Re: Plot 11/6 M.M.I. Machinman Q.

BUILDING SURVEYOR'S REPORT.

With reference to your application dated 5-8-36
with a plan for the proposed building/additions and alterations on plot
No. 11/6, Survey Sheet No. M.M.I. Machi M Quarter
I have to request you to comply with the following requirements:—

PROPOSED BUILDING ON PLOT NO 11/6 MM.
MACHHIMIAHI QUARTER
SCALE 8"=1"

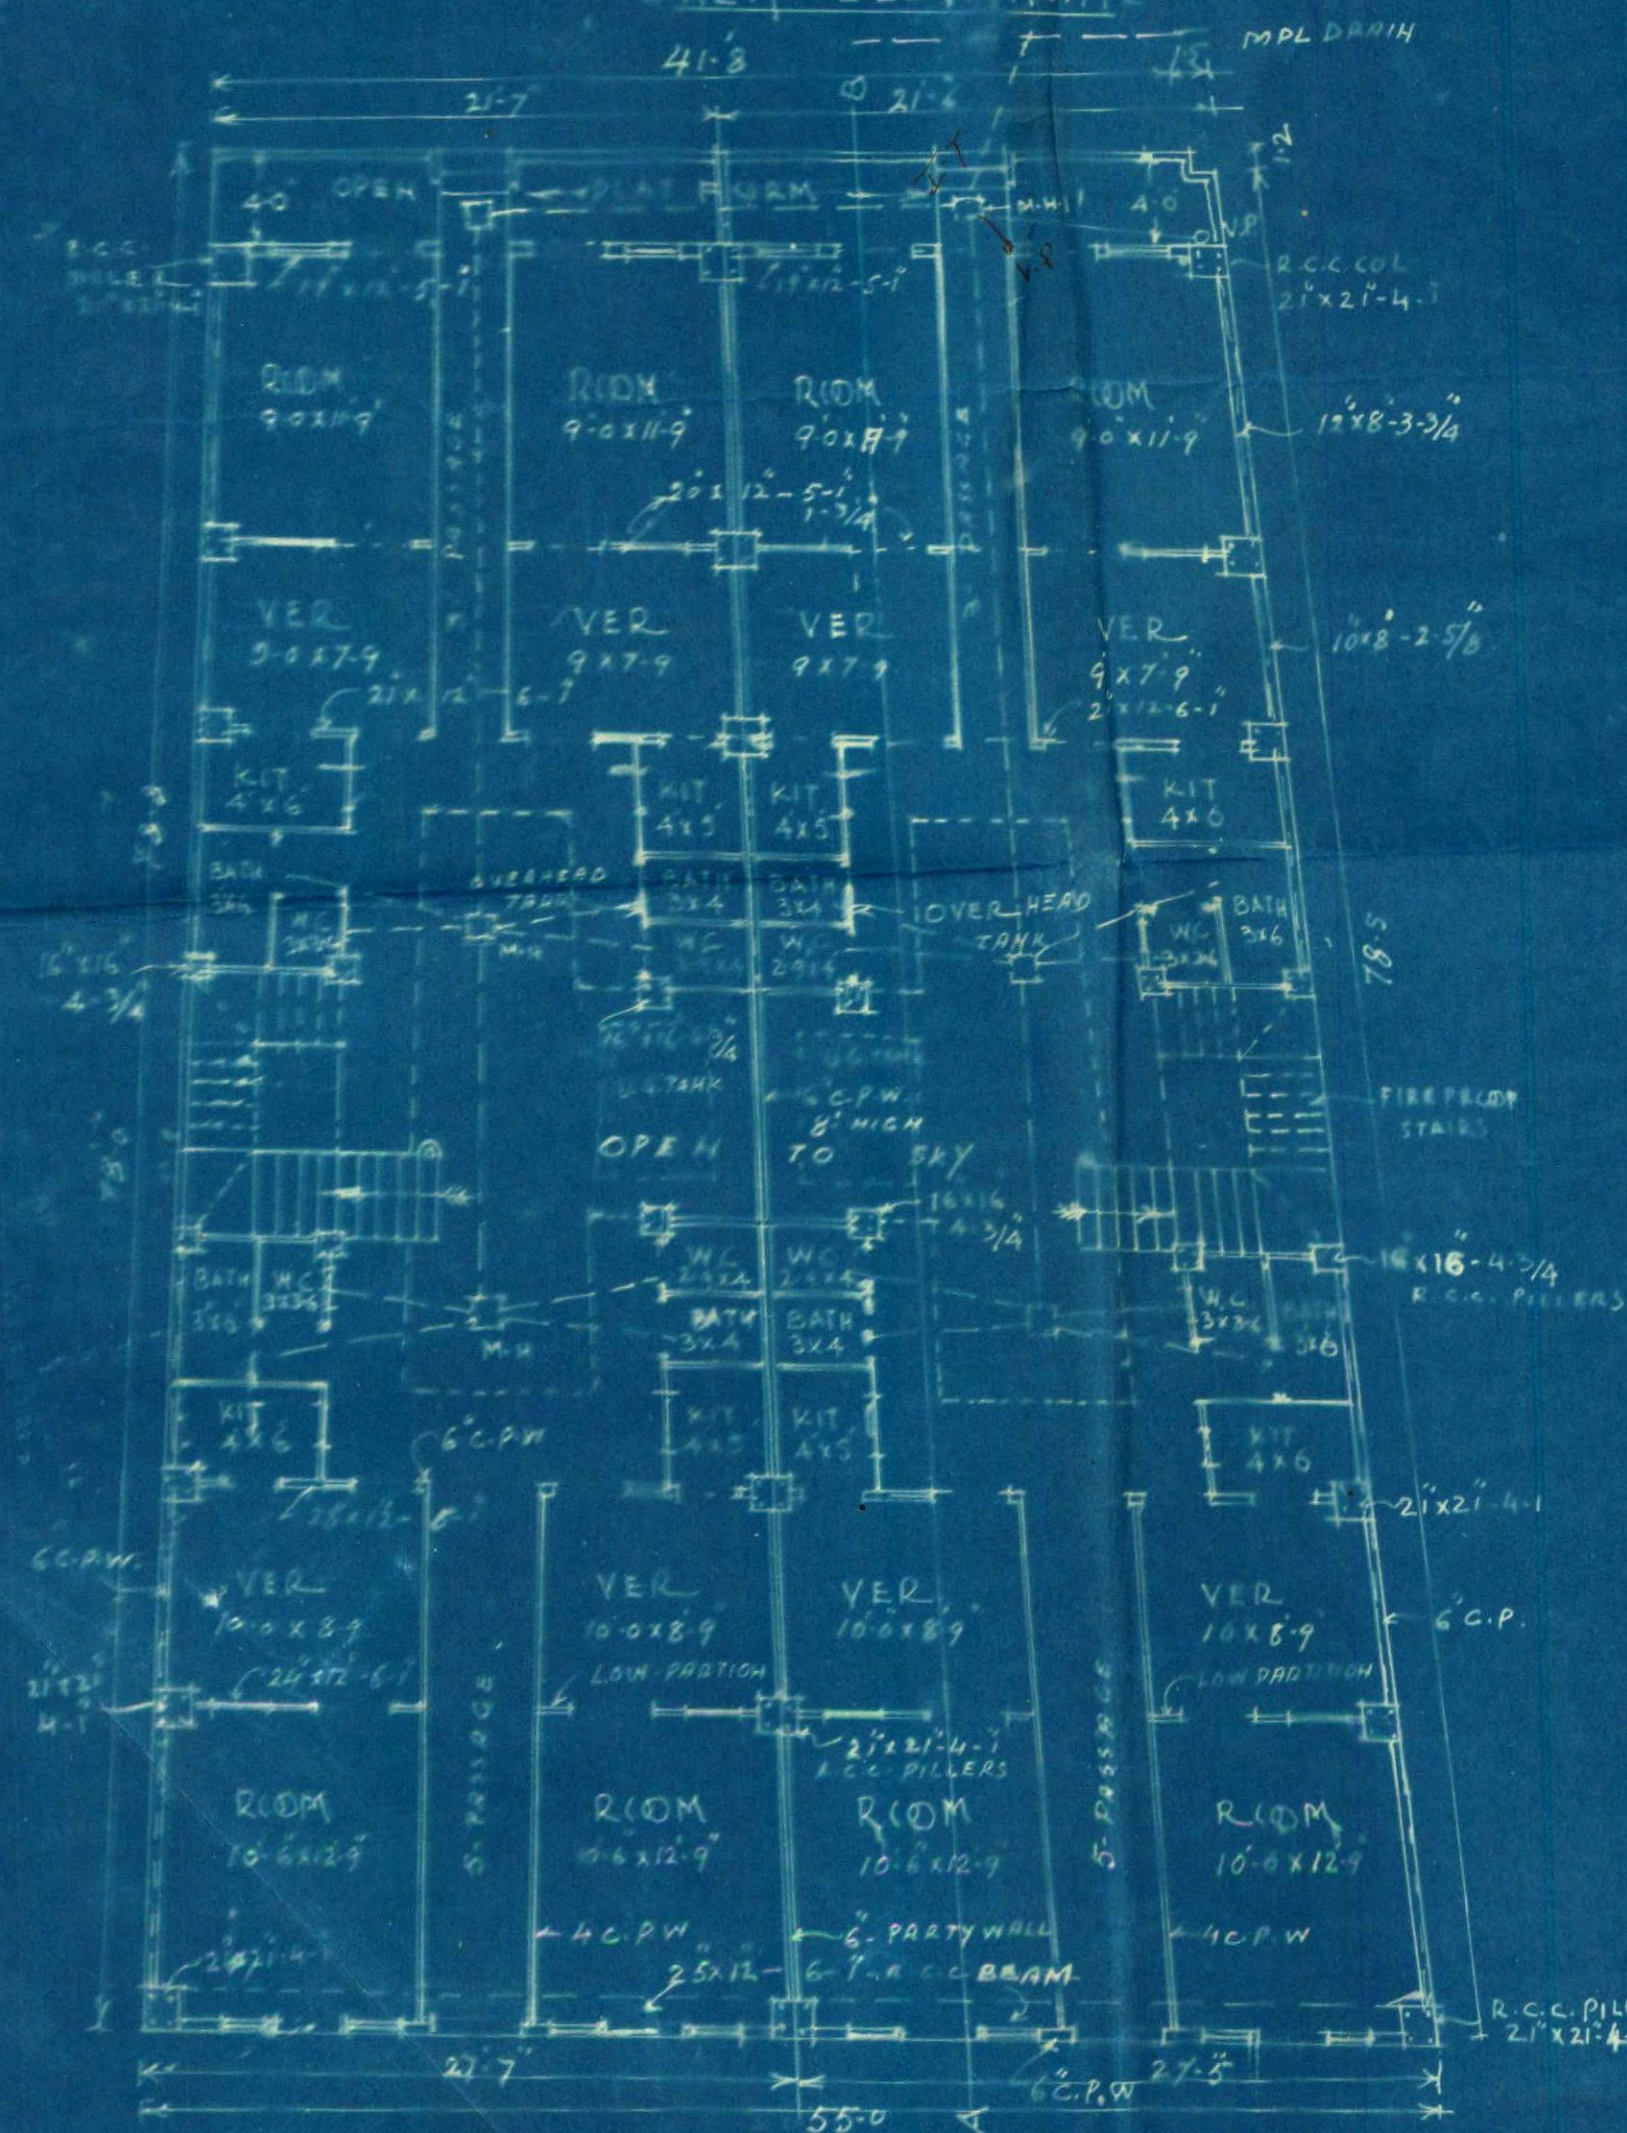
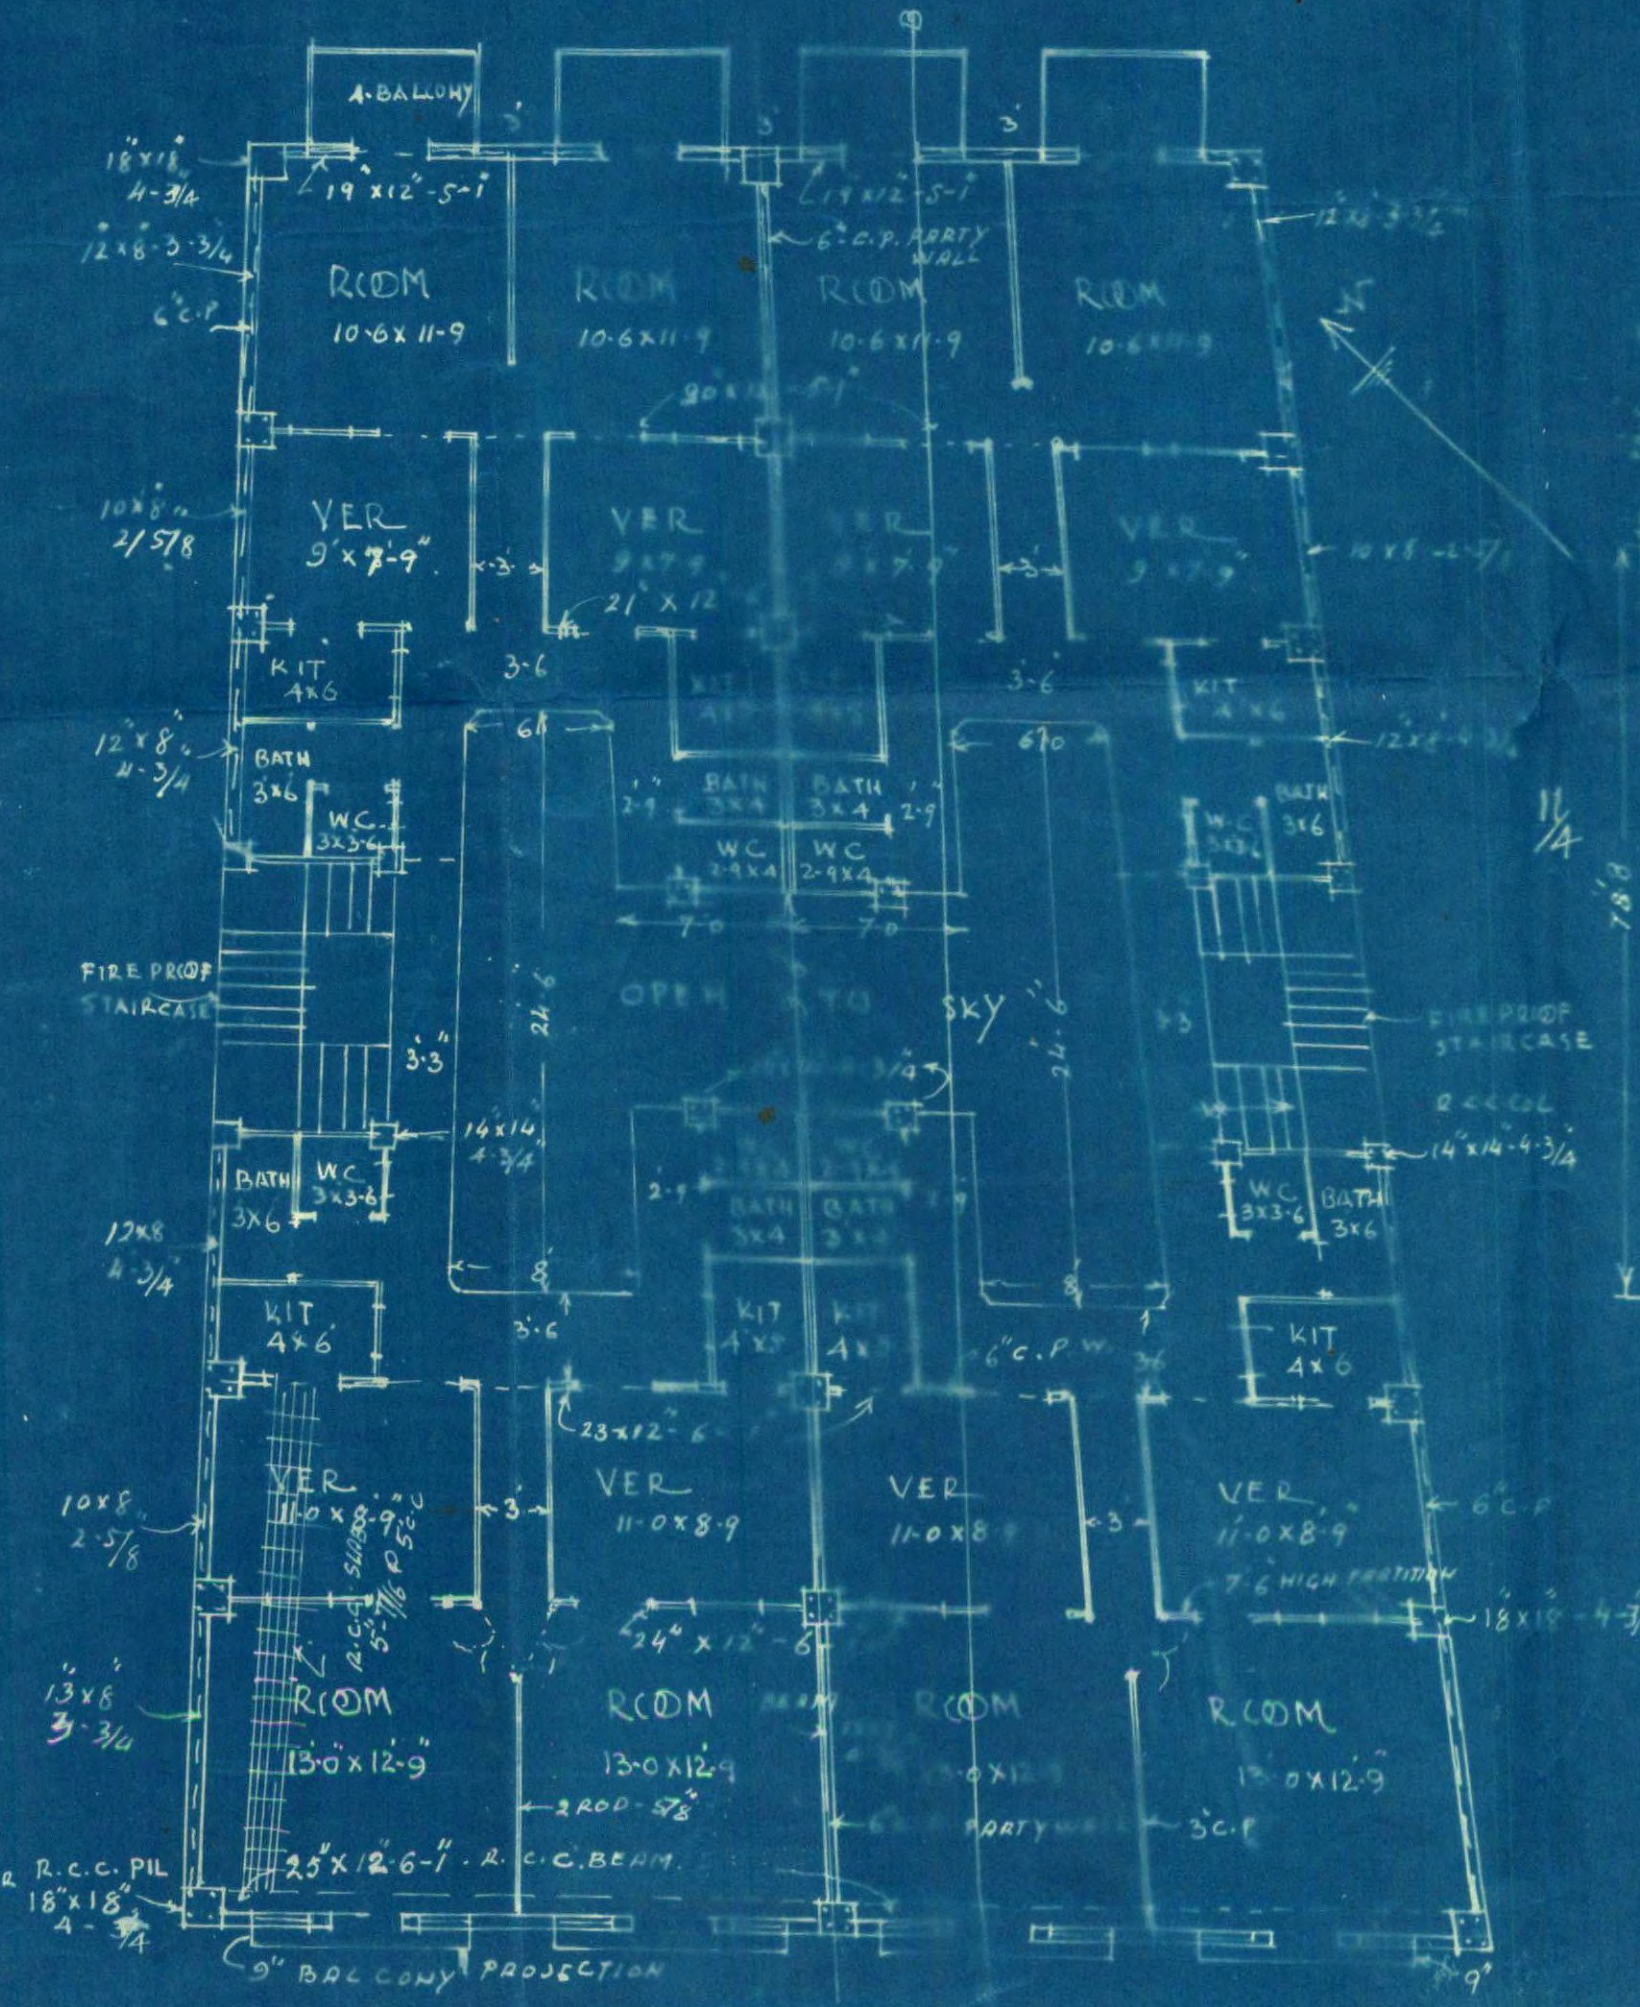
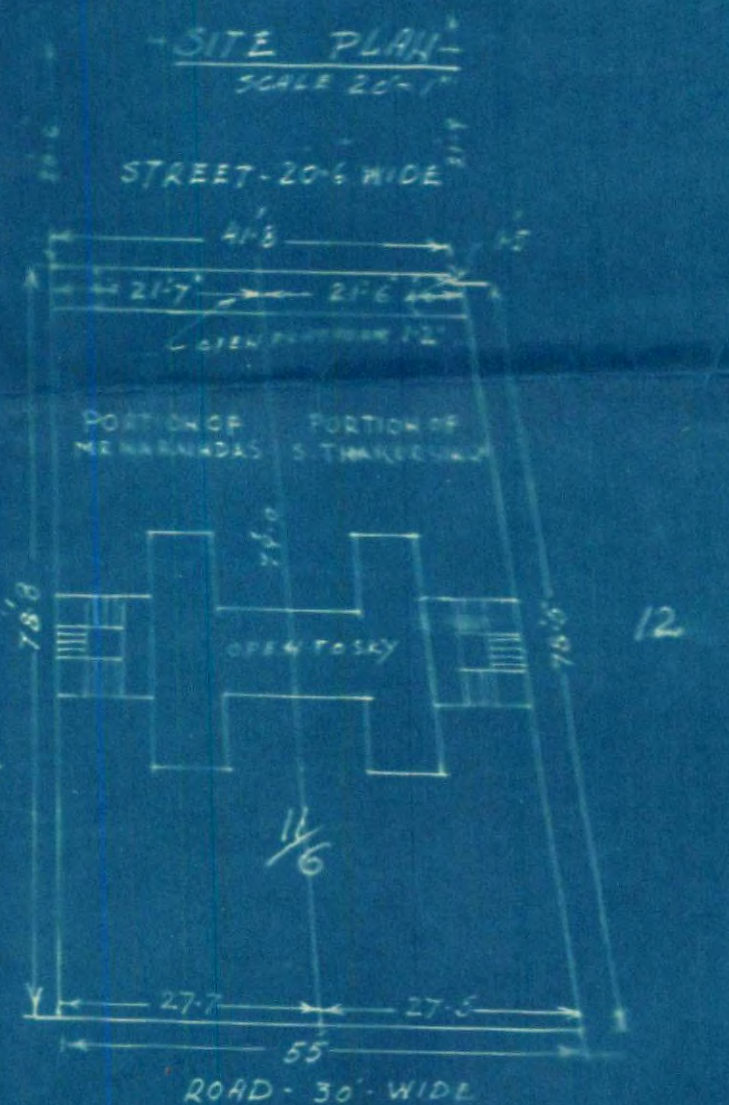
1. Width of the internal open is not sufficient for the proposed height.
2. The design is very congested.

*The architect's letter of 20/8/36 is
perused in which he states that staircase
is to be open to sky and the internal
partitions between front room & back
verandah will be 7-6" high...
Orders are requested.*

(1) The width of the ^{internal} open space is not so broad at the ends ^{only} due to projection of outhouses. In the centre of the plot, the entire width of the plot has been kept open to sky except the staircase at one end which is also proposed to be kept open to sky with an open well in the centre.

It is only the verandahs, kitchens, baths & WCs which abut on this open space. The proposed open will be quite adequate for light & ventilation of these outhouses.

Besides the partitions between verandahs and rooms which abut on streets are proposed to be kept low i.e. 7'-6" high as shown on plans for through ventilation and light. Verandahs are ^{not} the living rooms for which so much width of open will be sufficient. The railing of the internal gallery is proposed to be kept as open. ^{under the circumstances} the proposed open will be quite adequate.

(2) The building has been so designed as to make each apartment self-contained, each having a room verandah, kitchen, bath & WC. The size are moderately good. Therefore about 100 sq. ft. including open staircases have been kept open from a plot of area 430 sq. ft. i.e. almost $\frac{1}{3}$. I request an early approval of plans.
